Access Compliance Report Public Rights-of-Way (Curb Ramps)

Intersection ID: 9995Main Street:BEATTIES_FORD_RDCross Street:FRENCH_STLocation:SWADA ID: 6E6B9EF5F30CRamp Type:PerpDiagInitial Pass/Fail:FailOverall Compliance:NoSeverity Score:25

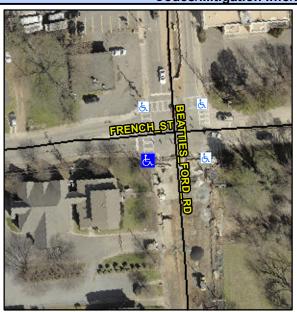
Not Found, R304.2.2

Field Measurements/Component Compliance						
	Compliance Description		Data	Compliance Description		Data
	N/A	Ramp Length (in)	60.0	No	Ramp Slope (%)	13.8
	Yes	Ramp Width (in)	68.0	Yes	Ramp XSlope (%)	0.6
	N/A	Flare Type LT	N/A	N/A	Flare Type RT	N/A
	N/A	Flare Slope LT (%)	N/A	N/A	Flare Slope RT (%)	N/A
	N/A	Flare Traversable LT?	N/A	N/A	Flare Traversable RT?	N/A
	N/A	Landing Length (in)	N/A	N/A	DWS Provided?	N/A
	N/A	Landing Width (in)	N/A	N/A	DWS Contrast?	N/A
	N/A	Landing Slope (%)	N/A	N/A	DWS Length (in)	N/A
	N/A	Landing X Slope (%)	N/A	N/A	DWS Full Width?	N/A
	N/A	Landing Curb? (Y/N)	N/A	N/A	DWS Offset (in)	N/A
	N/A	Shared Landing?	N/A			
	N/A	Gutter Ponding?	Yes	N/A	Gutter Slope (%)	N/A
	N/A	Gutter Lip Ht (in)	N/A	N/A	Gutter X Slope (%)	N/A
	N/A	Painted X Walk1?	Yes	N/A	Painted X Walk2?	Yes
		X Walk 1 Direction	To E		X Walk 2 Direction	To N
	N/A	X Walk 1 Width (in)	102.0	N/A	X Walk 2 Width (in)	106.0

Remove & Replace Curb Ramp With
Two New Directional Ramps or
Equivalent.
